RFQ CCC-039 Instructional Building #1 - ADDENDUM 1

1. Pre-Bid RFC-001 through 004 and RFC-006 through 011 with Answers

2. Changes to the Specifications

3. Changes to the Drawings

A9.01
 75-15238-00

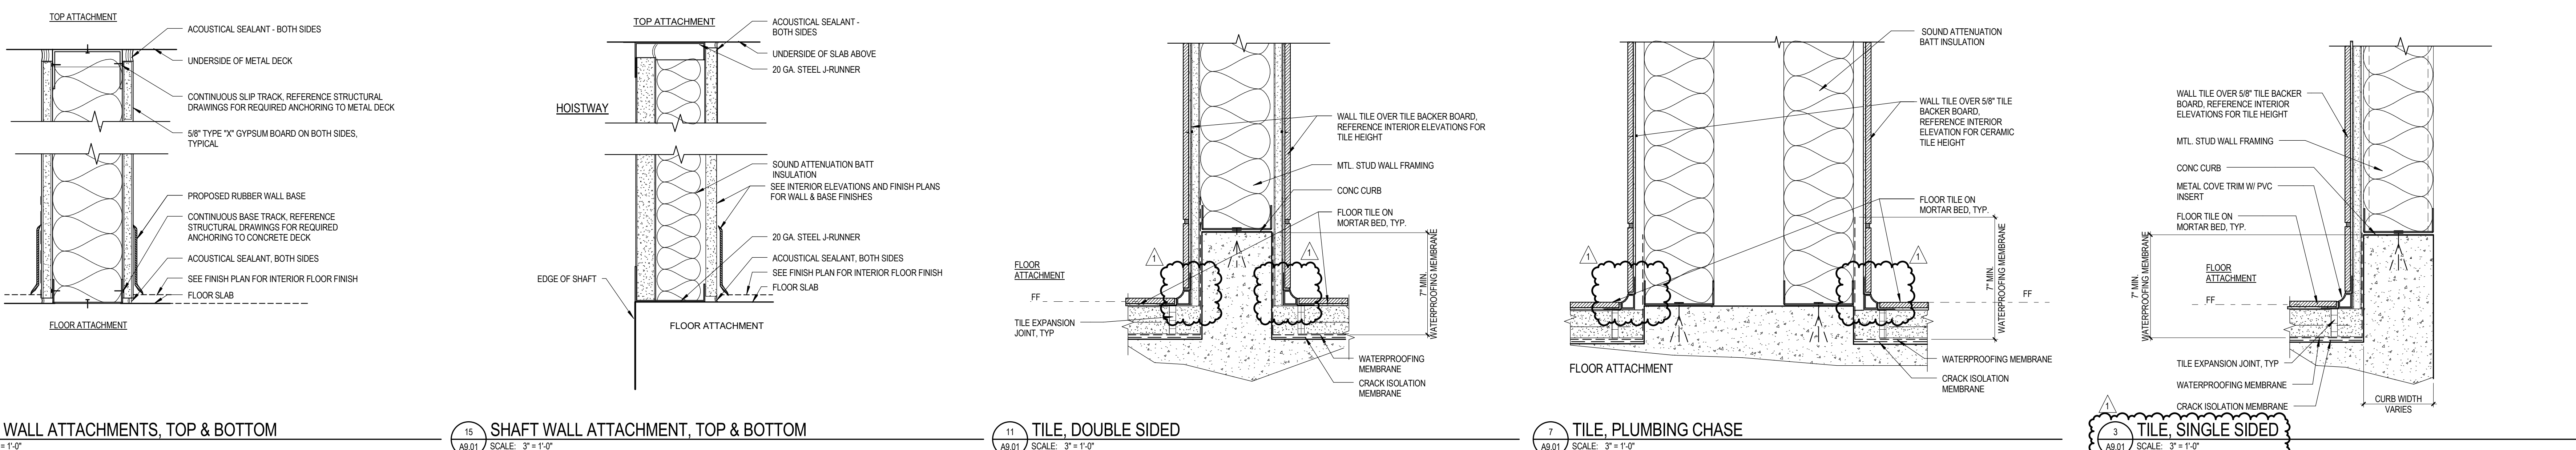
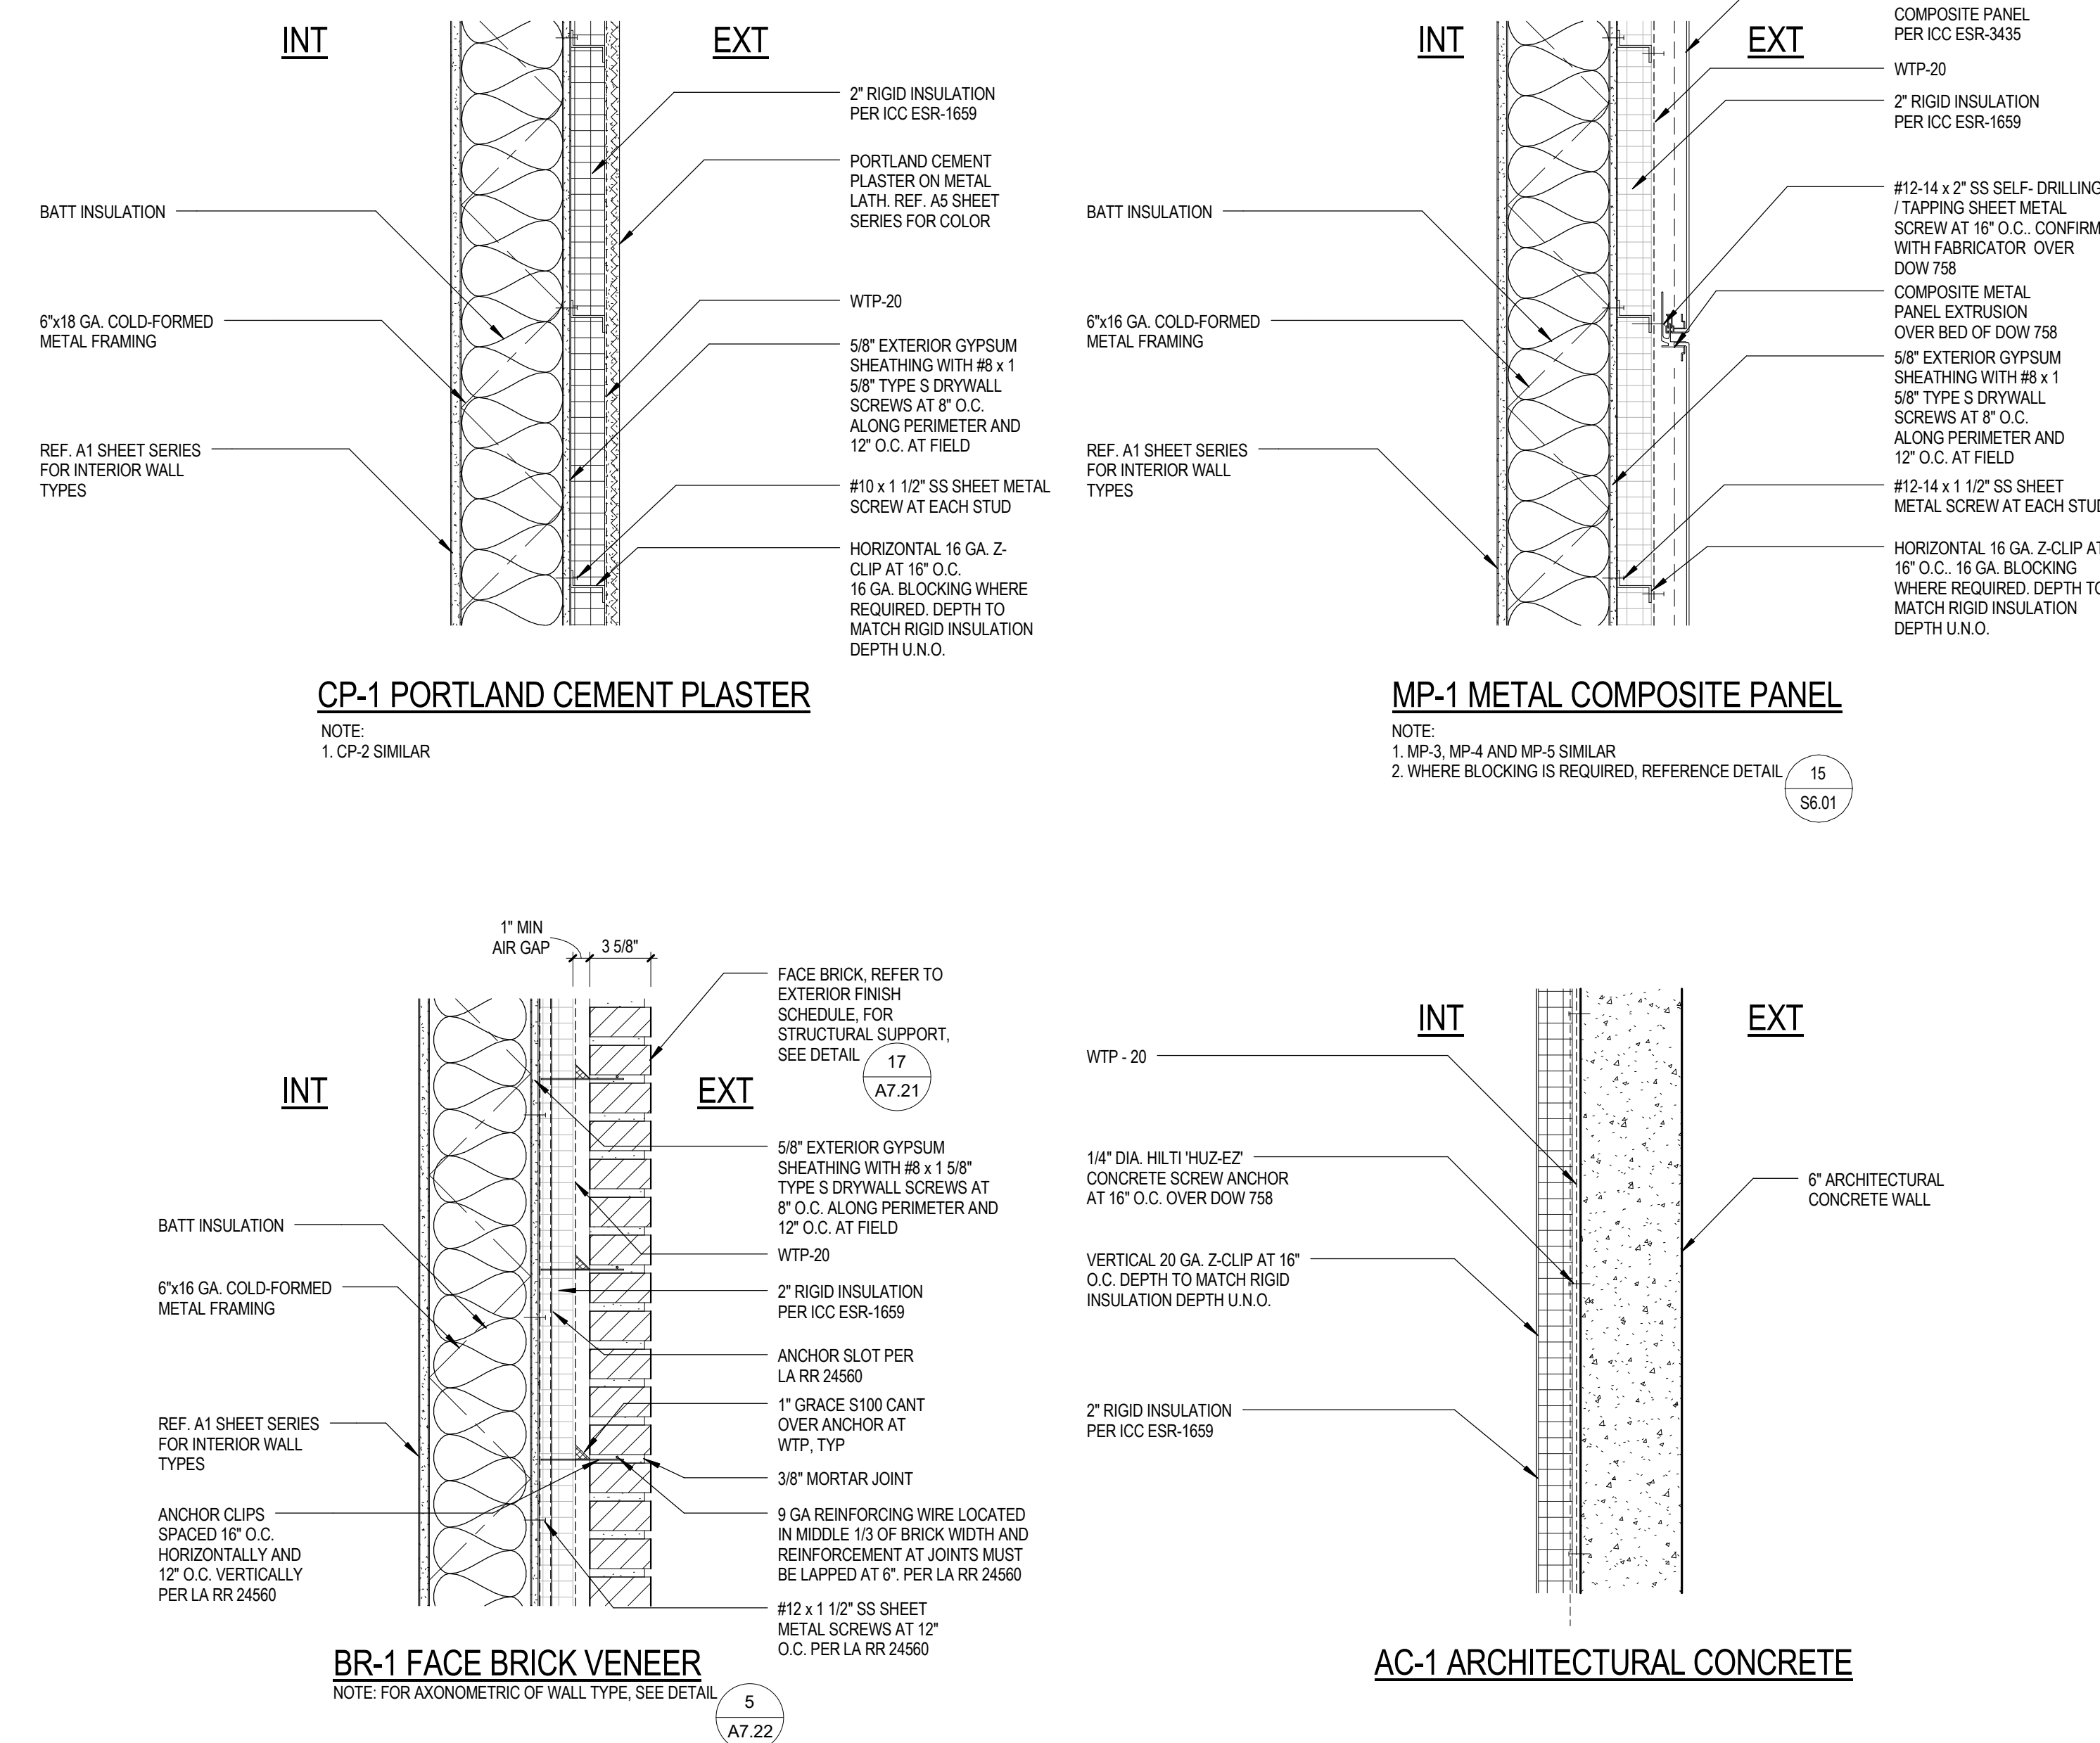
Sheet A9.01 – WALL TYPES, EXTERIOR AND INTERIOR

- C. Revised Keynote for S1, S2, and S3 Interior Wall Types: Added "Substitute 5/8" Densglass Board Substrate where tile occurs"
- D. Revised Details 7 and 11 showing cove trim at corner per 4/A10.06.
- E. Added Detail 3/A9.01 – TILE, SINGLE SIDED: Showing conditions in restroom wall furring.

MECHANICAL PIPING PLAN - LEVEL 1
 MP1.01 SCALE: 1/8" = 1'-0"

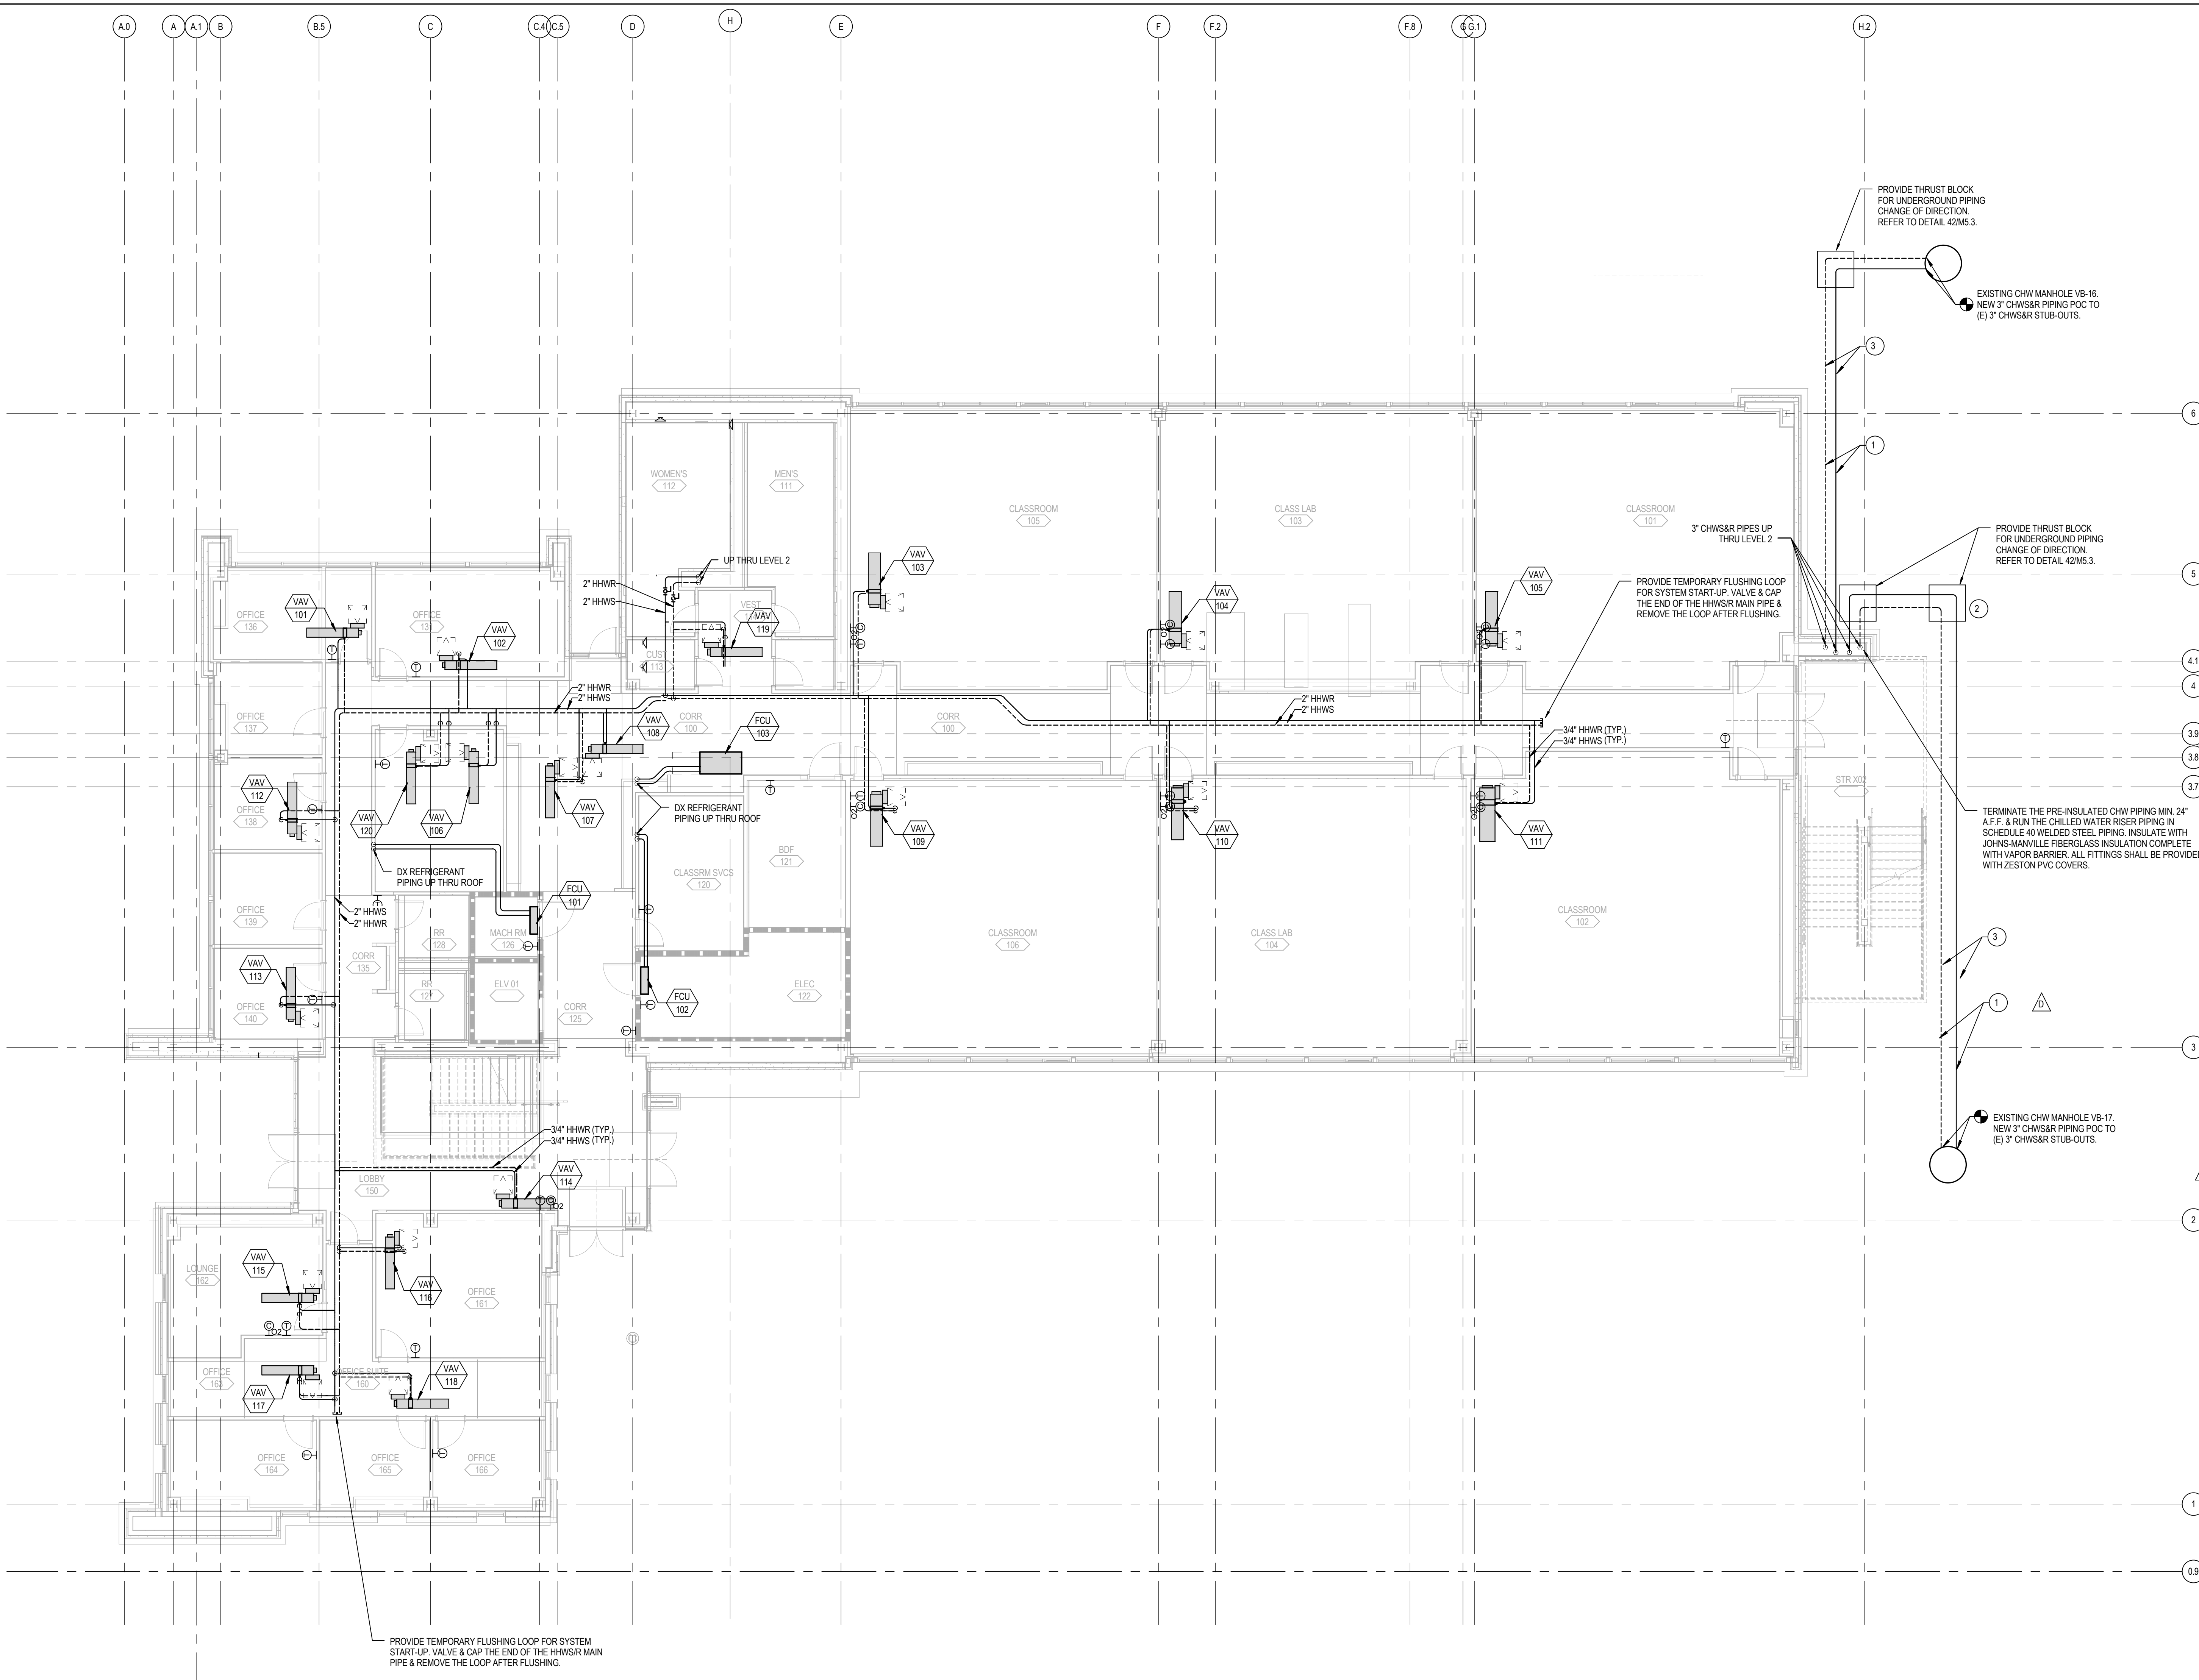
Sheet MP1.01 – MECHANICAL PIPING PLAN – LEVEL 1

- A. Edit Keynote 1 addressing underground chilled water piping.
